**UNITED STATES
NUCLEAR REGULATORY COMMISSION
ADVISORY COMMITTEE ON REACTOR SAFEGUARDS
WASHINGTON, DC 20555 - 0001**

April 26, 2012

**SUBJECT: DRAFT COMMISSION PAPER, "RISK-INFORMED REGULATORY
FRAMEWORK FOR NEW REACTORS"**

Figure 1. Relative Risk Significance Concept

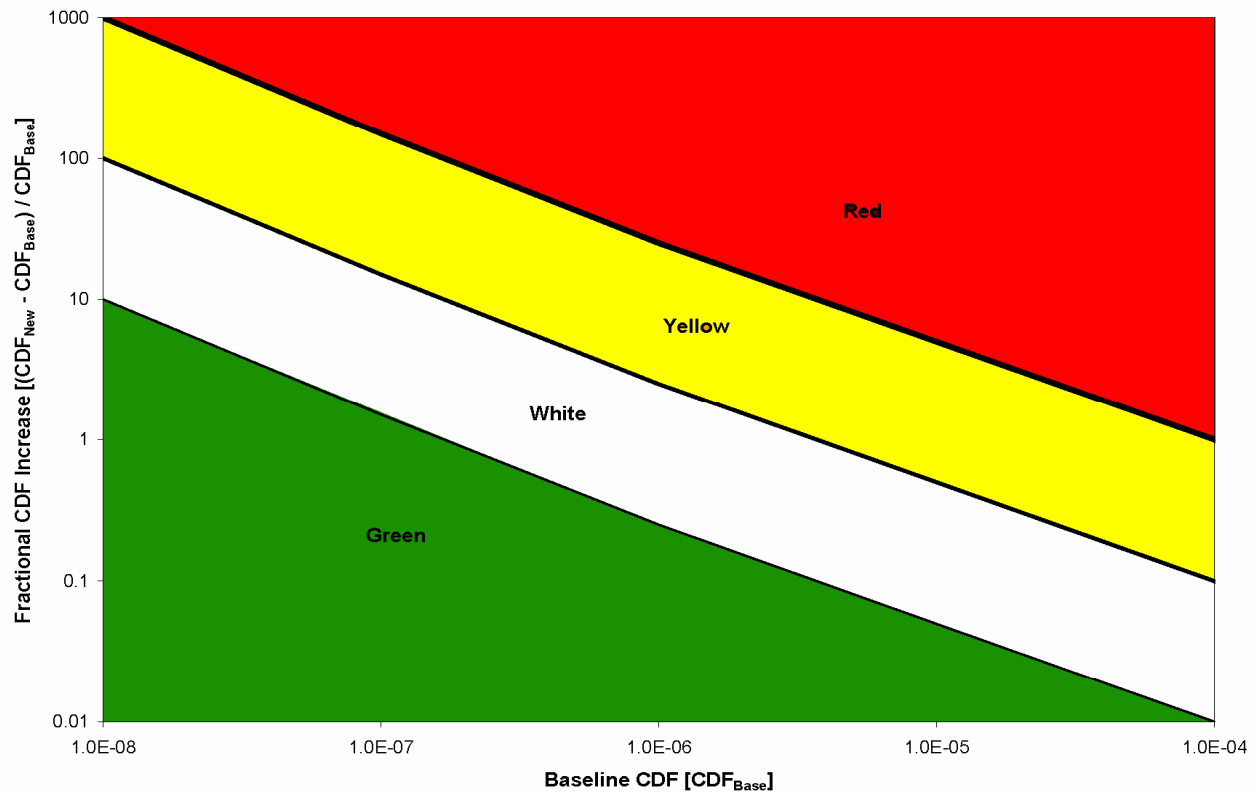
A rigid application of relative risk measures would not address the Commission direction to provide greater operational flexibility for reactors with increased margins of safety. Figure 1 is a conceptual framework in which the permitted relative change in CDF is dependent on the baseline CDF. The logarithmic scales for this metric accomplish the stated desire to provide increased operational flexibility as the absolute safety margin increases. The numerical values for the vertical scale can be selected to preserve the SDP metrics that are currently applied for operating reactors and to provide appropriate numerical discrimination for reactor oversight and other regulatory decisions for new reactors.

Example values are shown on Figure 1 to illustrate how this concept could be implemented in practice. If the baseline CDF were 1.0×10^{-4} event per year, a White significance finding would be triggered if the CDF increases by 1%. This is equivalent to the current SDP threshold absolute increase of 1.0×10^{-6} event per year. If the baseline CDF were 1.0×10^{-8} event per year, a White significance finding would be triggered if the CDF increases by a factor of approximately 10. This is equivalent to an absolute increase of 1.0×10^{-7} event per year. As intended, the corresponding significance determination appropriately maintains the enhanced level of overall plant safety, supports improved decisions for increased regulatory oversight, and provides substantially increased operational flexibility, compared to current reactors.

This concept should be implemented by consistently extending the decision framework of Regulatory Guide 1.174. Appropriate values for these metrics, the shapes, and the slopes of the significance determination transitions would be developed through stakeholder interactions, informed by the available tabletop exercises or an expanded set of case studies.
